INDESIT company

BCS333AVEI
BCS333AVEIS

F027597
F027598
F029153
F029154

0522067: SEALS FOR DOORS FOAMED AS ONE PIECE

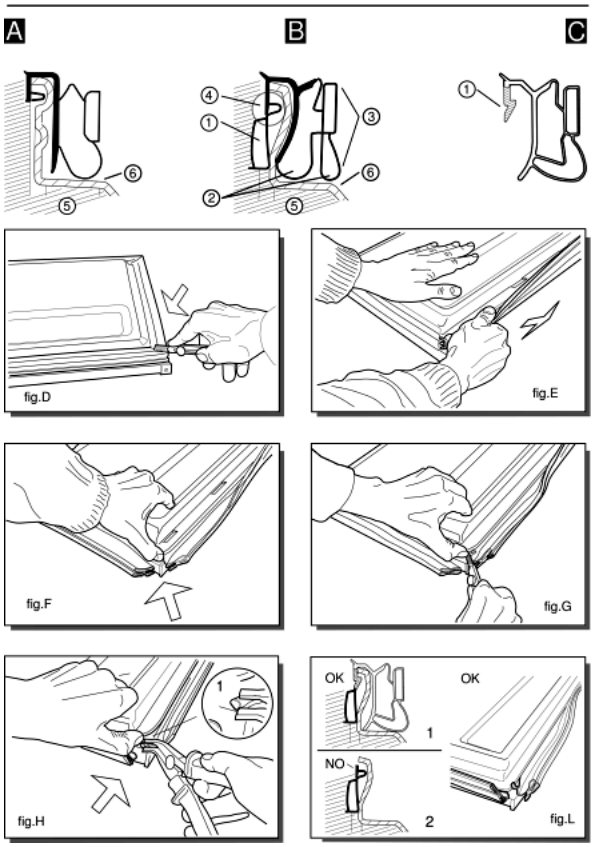
Various types of gaskets with different profile, as shown in figures (A) and (B), are used to fix the door (fig. A-5; B-5) and the inner door (fig. A-6; B-6) on the block foamed doors of combined freezers and refrigerators.
---Ilpea profile 245; 179; 412 (fig.A)
---Ilpea profile 287 (fig.B)
When replacing gaskets with profiles 245; 179; 412 these are fixed with screws (2 per corner) to the door.
Gaskets with profile 287 can not be used as spare parts but are designed to house the Ilpea type 900 gaskets (see figure C).
When replacing the gasket (287), once it is removed you will find a pocket (fig. B-1) between the door and inner door.
The rigid tooth (fig.C-1) of the gasket (900) is inserted inside between the pocket and the inner door, doing away with the need for screws.
Gasket with profile 287 is easy to identify since it has an exterior double edge (fig.B-2) which acts as a cushion when the door is closed.

To replace this gasket, follow these steps:
---Dismount the door and cut the four corners of the gasket along the joint (fig.D);
---lift the gasket and pull it carefully along its full length without tearing it (fig.E).
The purpose here is to detach the inner door slightly from the foam along the exterior edge for a depth equal to that of the gasket (fig.B-3);
---lift the corner of the inner door slightly, prising it up with your thumb (fig.F). Do not use a tool which might break the inner door;
---continue cutting the gasket inside the inner door for about 6 mm (fig.G);
---push in the tip of the pliers (type USAG N131) and pull outwards until you see the top edge of the pocket (fig. B-4) which is empty (fig.H-1);
---if you carry out this operation correctly (fig.L) you will be able to pull off the top edge of the pocket for the full length of the door.
If the gasket tears before the top edge (fig. L-2) you should repeat this operation from the other corner of the door.

---once the gasket (287), has been removed the space above the pocket (fig. L-1) can house the rigid tooth (fig. C-1) of the gasket 900.
When you fit this gasket ensure that it lies flush against the edge for the full length of the door.
If the rigid tooth is difficult to fit, eliminate any residues of foam between the door and the inner door in the gasket area.
fig.5131549A

n1030064: Elimination of sensor cage on 2002 range built-in fridge-freezers models BCS313

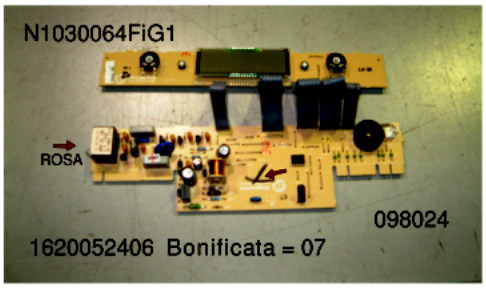
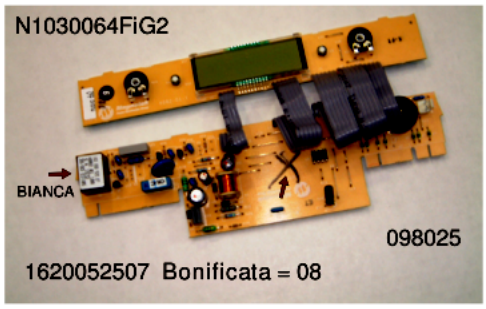
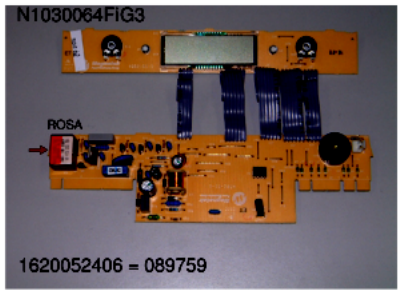
In April 2003 (serial no. 30407.0001) the Carinaro factory eliminated the cage protecting the fridge air sensor and moved the sensor 5-6 cm back on Ariston built-in electronic fridge-freezers.

This structural modification has involved the use of new electronic cards with warmer setting, because the sensor is less sensitive in the new position than in the previous more forward position with cage.

The Magnetek cards 162000524… (4083/PINK) and 162000525… (4082/WHITE) currently in stock in the Fabriano spare parts warehouse have all been replaced in order to be aligned with that used by production to date. These cards have been highlighted (see photo) with the marker pen, while the Magnetek codes (not higher than 162000524.06 and 162000525.07) are shown on the plates.
They will be managed with the following new Sat codes to enable correct ordering with respect to the previous ones.

The previous cards, with colder settings, do not have any highlighted marks and continue to be managed with the same Sat code (089759 and 088529=143093 ROHS) and must only be used on models with fridge air sensor in forward position and complete with cage.

Also, card 16200084501 will be managed with code 088529=143093 ROHS (4082/GREEN), currently used on the self-supporting fridge-freezer, which has the same settings as the previous card 16200052507 (4082/WHITE); whereas a card with red stamp on the pink plate (see photo) will be managed with code 089759.

Since November, electronic cards, with warmer settings, give the code 16200052407 for 4083/PINK and 16200052508 for 4082/WHITE on the plate, and must only be used on models with fridge air sensor without cage and in the back position.

.
New parts
098024 = (143091 ROHS) CARD (MAGNETEK 4083/PINK) new (no-frost models without cage)
098025 = (143092 ROHS) CARD (MAGNETEK 4082/WHITE) new (static models without cage)

Parts replaced
089759 - CARD (MAGNETEK 4083/PINK) 220-240/50 + red stamp (no-frost models with cage)
088529 = (143093 ROHS) CARD (MAGNETEK 4082/PINK) 220-240/50 (static models with cage)

n1030072: New 220-240V /50-60 Hz fan unit C09R1907 (KIT 077159 and 081971) Carinaro

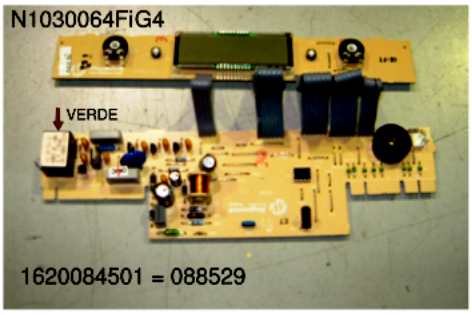
At the end of March 2004 the Carinaro factory replaced the fan unit in kit 077159.

The new fan unit (C09R1907) differs from the previous one (C09R1846) in the rpm reduction from 2290 to 2000, 3.5 Watt power, Class B, 220-240V/50-60 Hz voltage and faston connectors (6.3x0.8 mm) remain the same.
This modification will also be extended to the Melano and Setubal factories for Kit 081971.
The new fan unit will be managed with the same Service code as the previous one (076024), once the stocks of the latter run out; the same will also be done for Kits 077159 and 081971.

N130084FIG1

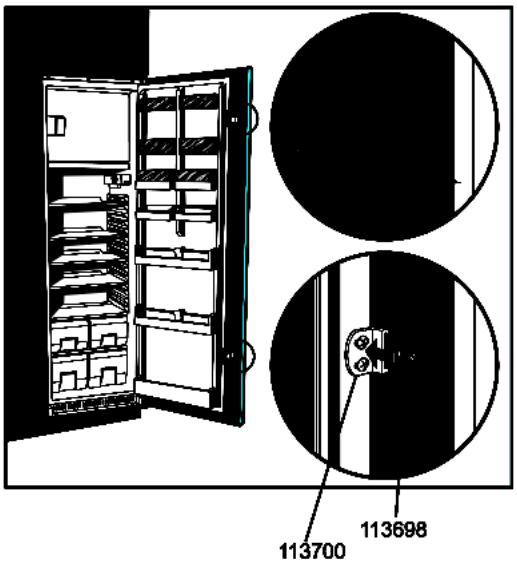
Since October 2004, the Carinaro factory has been using new sliding blocks for fixing the furniture door to the refrigerator door.
The new items are fixed to the side of the refrigerator door, whereas the previous ones were fixed to the front.
The doors are no longer provided with sixteen 2.6 mm holes on the front for fixing the old slides.
The new sliding blocks can also be fitted on premodification models. Proceed as shown in the attached figure (N1030084fig.1).
When replacing the sliding blocks on premodification models it will necessary to replace both guides.
This modification has involved changing the installation KITS

NB - Door spare part codes have not been changed.

113698 - LARGE NYLON HOLDER SLIDE
113700 - NYLON HOLDER SLIDING GUIDE

021258 - SMALL WHITE SLIDE + COVER
021259 - WHITE SLIDE
